MIL-M-63320A(AR)
AMENDMENT 2
19 November 1982
SUPERSEDING
AMENDMENT 1
25 MARCH 1982

MILITARY SPECIFICATION

MICROCIRCUIT, DIGITAL, CMOS (INITIAL LOGIC)

This amendment forms a part of Military Specification MIL-M-63320A(AR) dated 8 April 1981, and is approved for use by the US Army Armament Research and Development Command and is available for use by all the Departments and Agencies of the Department of Defense.

FIGURE 1. Test Circuit for Leakage Current (Oscillator) and Oscillator Function tests.

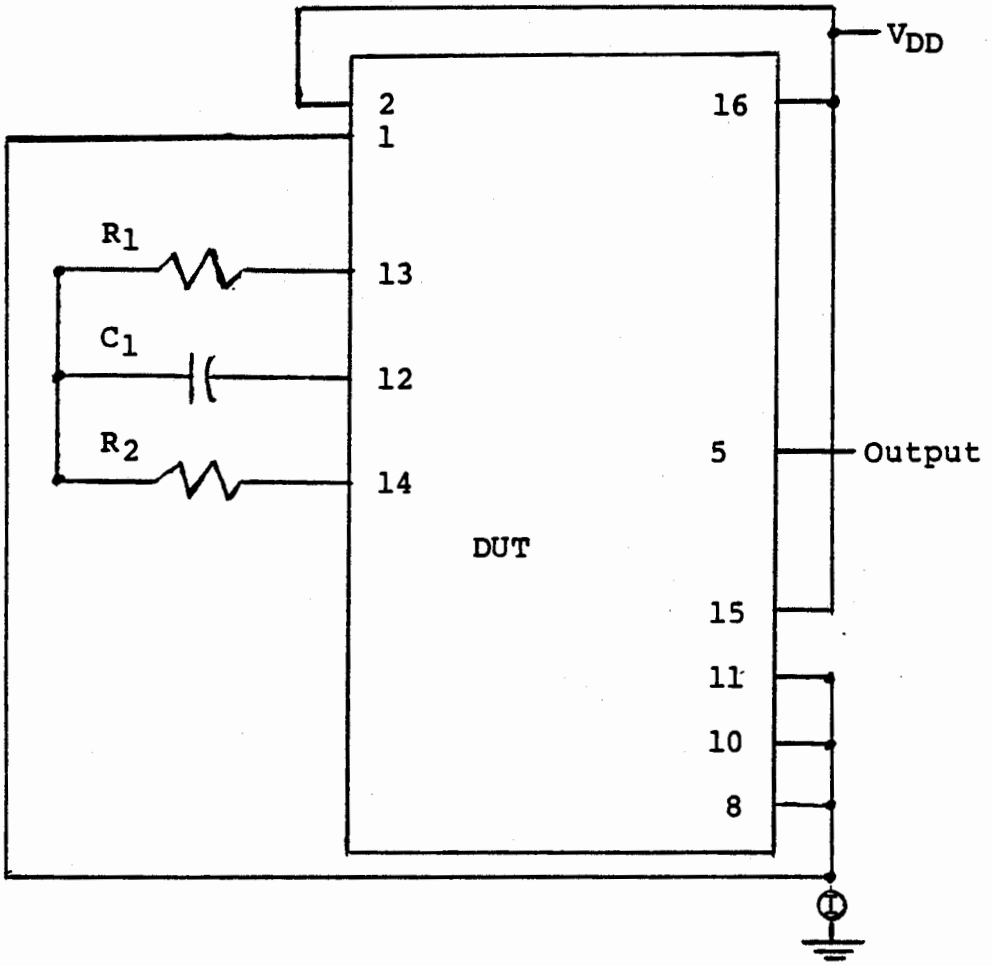
FIGURE 1: Delete present and substitute revised FIGURE 1 attached to this amendment.

FIGURE 15. Burn-in and Steady State Life-Test Circuit.

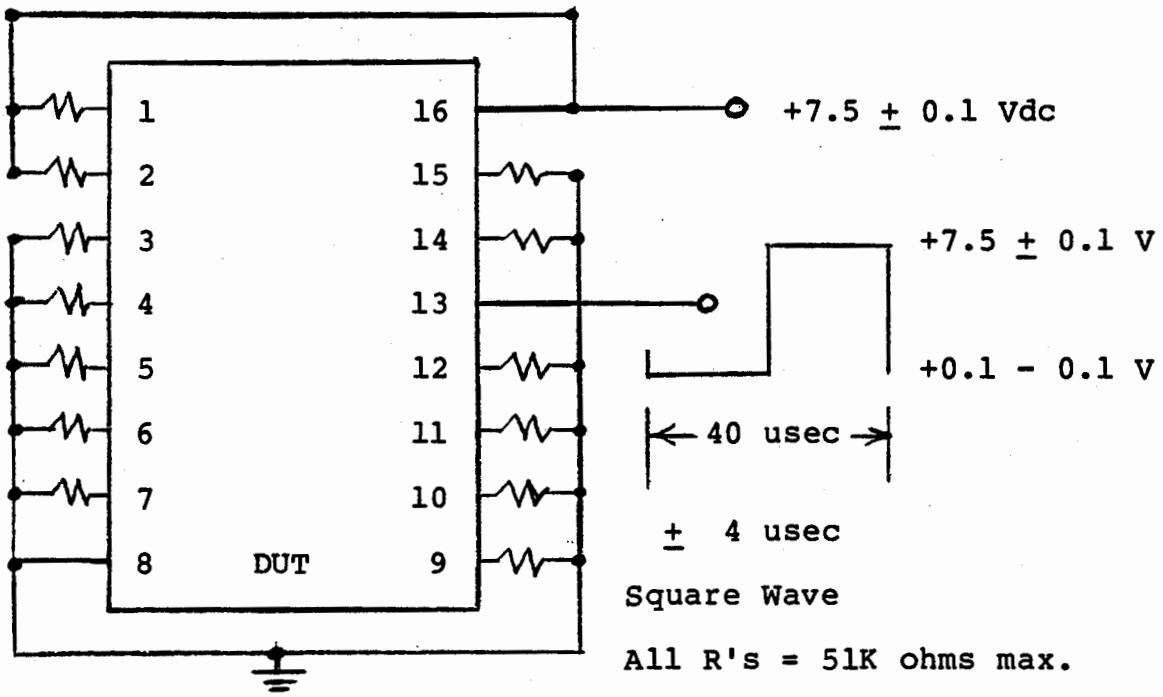
FIGURE 15: Delete present and substitute revised FIGURE 15 attached to this amendment.
